Access Compliance Report

Public Rights-of-Way

(Curb Ramps)

Intersection ID: 4687	Main Street: EVANSHIRE_DR	Cross Street: FELDBANK_DR	Location: NW
ADA ID: B766E9AF4ADD	Ramp Type: BlendTrans2	Initial Pass/Fail: Fail	Overall Compliance: No
		Severity Score: 36.25

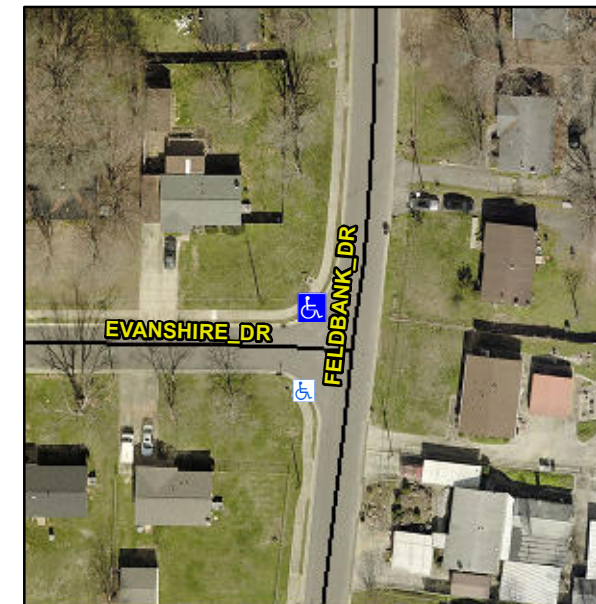
VEGETATION OVERGROWTH

Not Found, R304.5.1, R304.5.3

Compliance	Description	Data	Compliance	Description	Data
N/A	Ramp Length (in)	84.0	Yes	BlendTrans Slope (%)	4.1
No	Ramp Width (in)	28.0	No	BlendTrans XSlope (%)	4.0
N/A	Flare Type LT	N/A	N/A	Flare Type RT	N/A
N/A	Flare Slope LT (%)	N/A	N/A	Flare Slope RT (%)	N/A
N/A	Flare Traversable LT?	N/A	N/A	Flare Traversable RT?	N/A
N/A	Landing Length (in)	N/A	N/A	DWS Provided?	N/A
N/A	Landing Width (in)	N/A	N/A	DWS Contrast?	N/A
N/A	Landing Slope (%)	N/A	N/A	DWS Length (in)	N/A
N/A	Landing X Slope (%)	N/A	N/A	DWS Full Width?	N/A
N/A	Landing Curb? (Y/N)	N/A	N/A	DWS Offset (in)	N/A
N/A	Shared Landing?	N/A			
N/A	Gutter Ponding?	N/A	N/A	Gutter Slope (%)	N/A
N/A	Gutter Lip Ht (in)	N/A	N/A	Gutter X Slope (%)	N/A
N/A	Painted X Walk1?	No	N/A	Painted X Walk2?	N/A
	X Walk 1 Direction	To S		X Walk 2 Direction	N/A
	X Walk 1 Width (in)	N/A		X Walk 2 Width (in)	N/A
	X Walk 1 Slope (%)	2.0		X Walk 2 Slope (%)	N/A
	X Walk 1 X Slope (%)	0.7		X Walk 2 X Slope (%)	N/A

N/A	Ramp inside XWalk1?	N/A	N/A	Ramp inside XWalk2?	N/A
	Road Slope (%)	0.7		Clear Space?	N/A
	Road X Slope (%)	2.0	N/A	Clear Space to XWalk (in)	N/A
N/A	Any Obstructions?	N/A	N/A	Storm Grate/Utility Hazard?	N/A
	Obstruction Type			Storm Grate/Utility Type	
		N/A			N/A
			Yes	Surface Condition? (G/P)	Good
			No	Curb Slope (%)	21.8

Remove & Replace Curb Ramp With Two New Directional Ramps or Equivalent.
